Technical Service Bulletin

Subject: Heat Pan Clearance

Applies To: All Rosenbauer and Commercial Chassis with a Diesel Particle Filter/Selective Catalytic Reduction system.

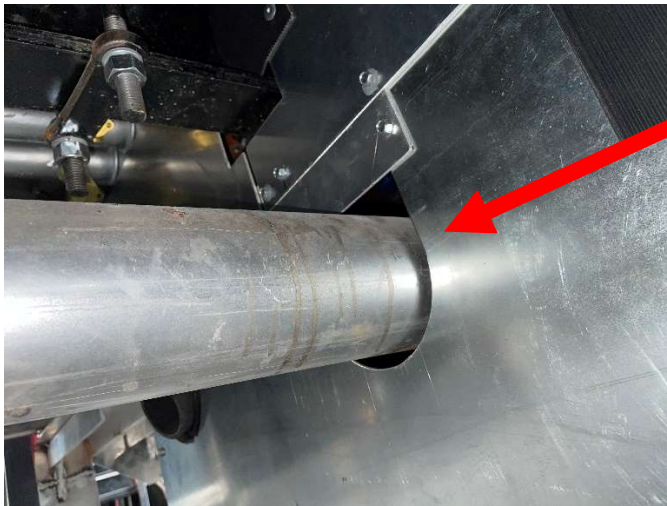
1" MINIMUM GAP AROUND THE
EXHAUST PIPE

3/4" MINIMUM GAP AROUND THE
ENTIRE DRIVELINE AND ALL OF ITS
COMPONENTS

1" MINIMUM GAP ALL THE WAY
AROUND THE AFTERTREATMENT

- 1" minimum clearance all the way around the aftertreatment.
- 1" minimum clearance all the way around the exhaust pipe.
- ¾" minimum clearance all the way around the driveline and driveline components.
- Pictures are on the next page.
